June 28, 2002
AEP:NRC:2900
10 CFR 50.90

SUBJECT: Donald C. Cook Nuclear Plant Unit 1
Docket No. 50-315
License Amendment Request for Appendix K Measurement
Uncertainty Recapture – Power Uprate Request

FIGURE 3.4-2

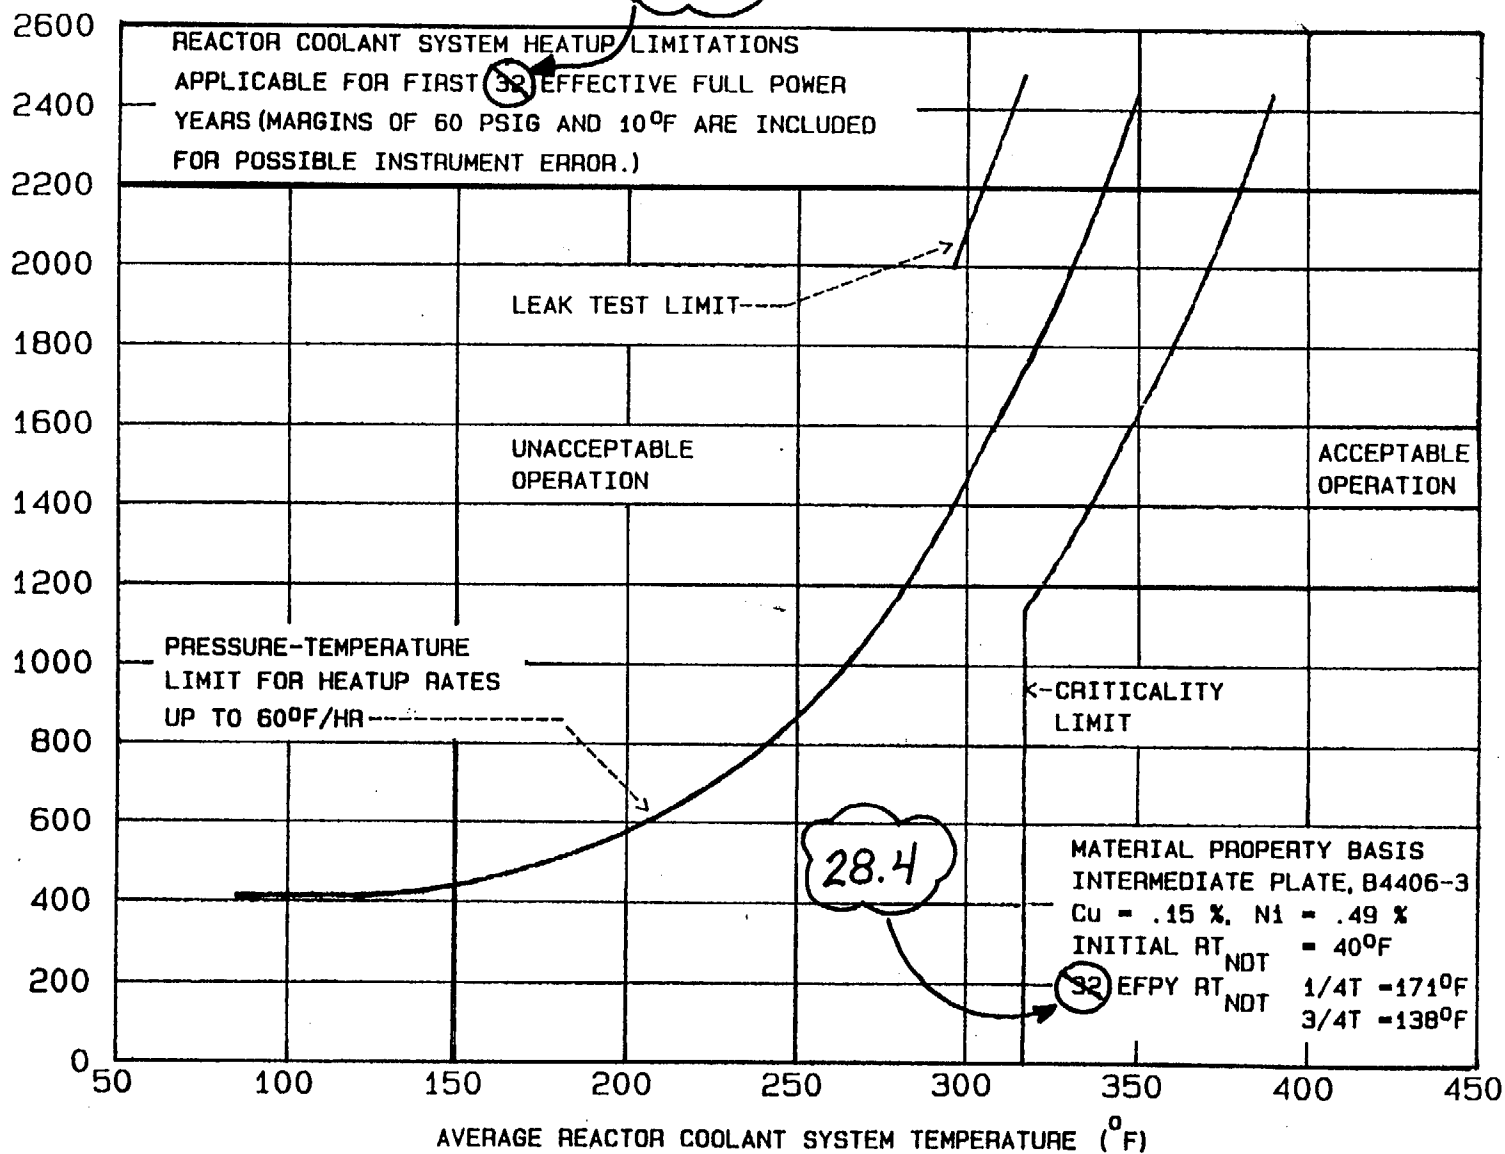
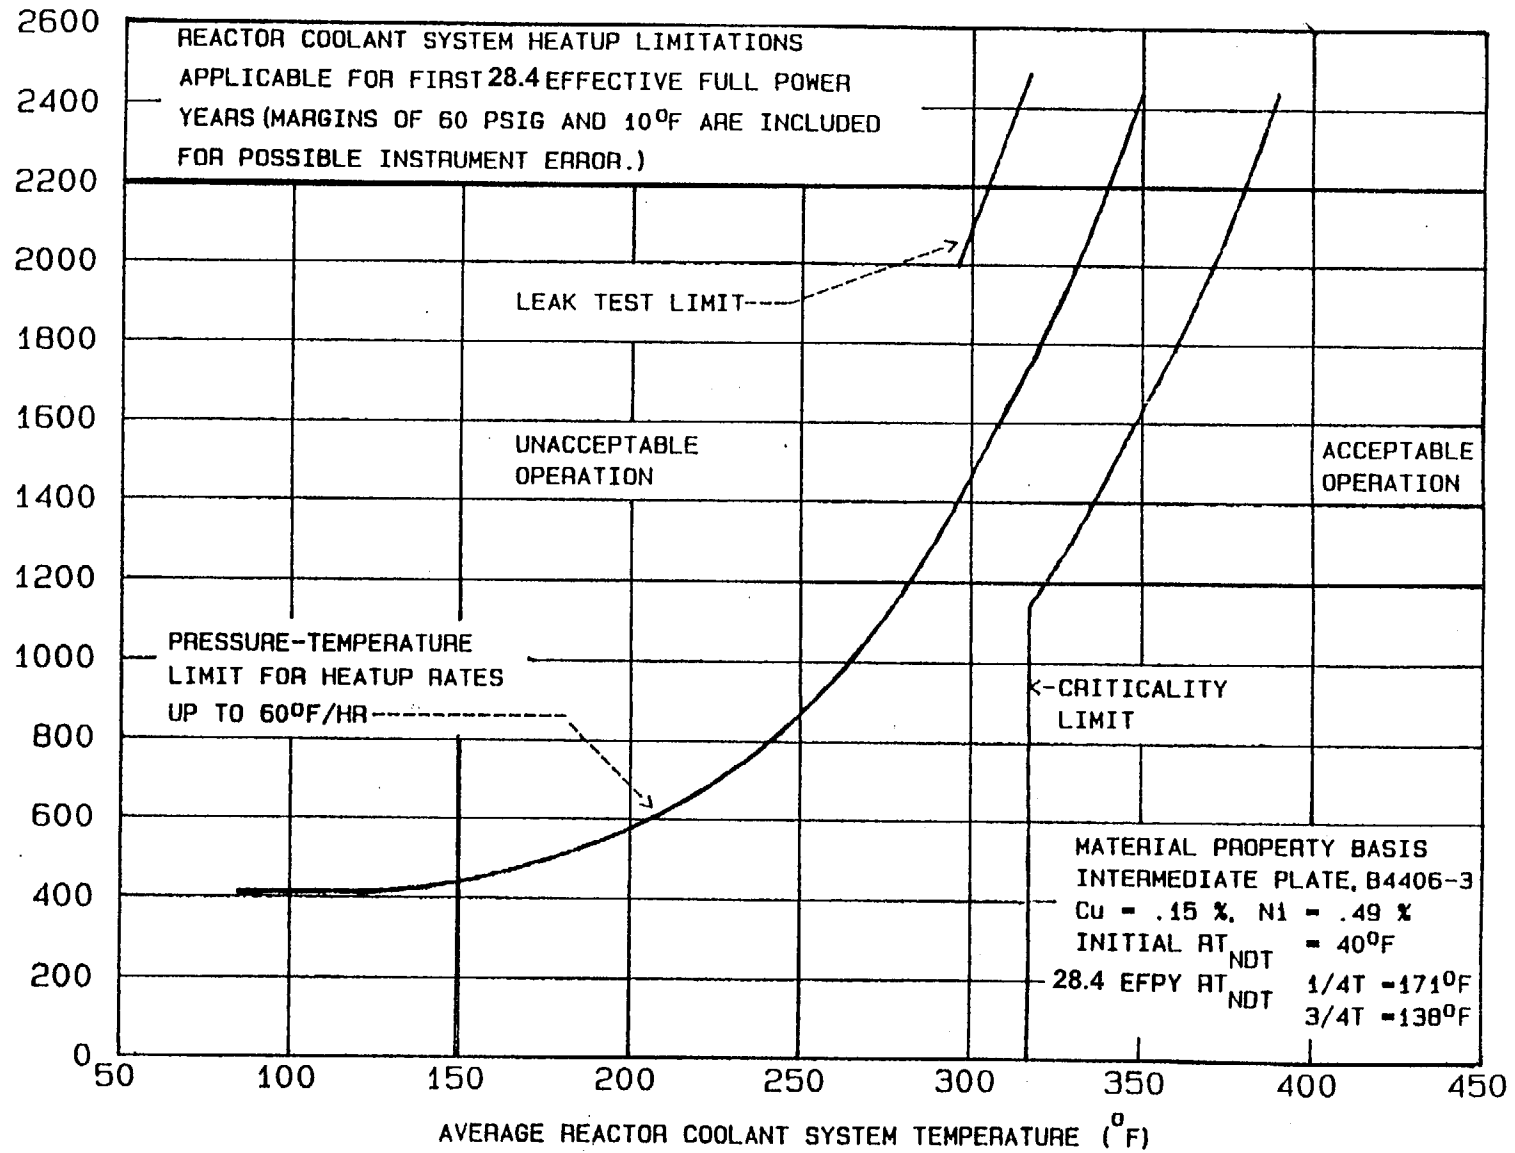
5. TS Figure 3.4-2 "Reactor Coolant System Pressure – Temperature Limits Versus 60°F/hr Rate Criticality Limit and Hydrostatic Test Limit," and TS Figure 3.4-3 "Reactor Coolant System Pressure – Temperature Limits Versus Cooldown Rates," are revised to reflect the new limit of applicability of 28.4 EFPY versus 32 EFPY. The TS Bases for LCO 3/4.4.9,

“Reactor Coolant System – Pressure/Temperature Limits,” are revised to reflect this change.

The heatup limit curve, Figure 3.4-2, is a composite curve which was prepared by determining the most conservative case, with either the inside or outside wall controlling, for any heatup rate up to 60°F per hour. The cooldown limit curves of Figure 3.4-3 are composite curves which were prepared based upon the same type analysis with the exception that the controlling location is always the inside wall where the cooldown thermal gradients tend to produce tensile stresses while producing compressive stresses at the outside wall. The heatup and cooldown curves were prepared based upon the most limiting value of the predicted adjusted reference temperature at the end of 32 28.4 EFPY.
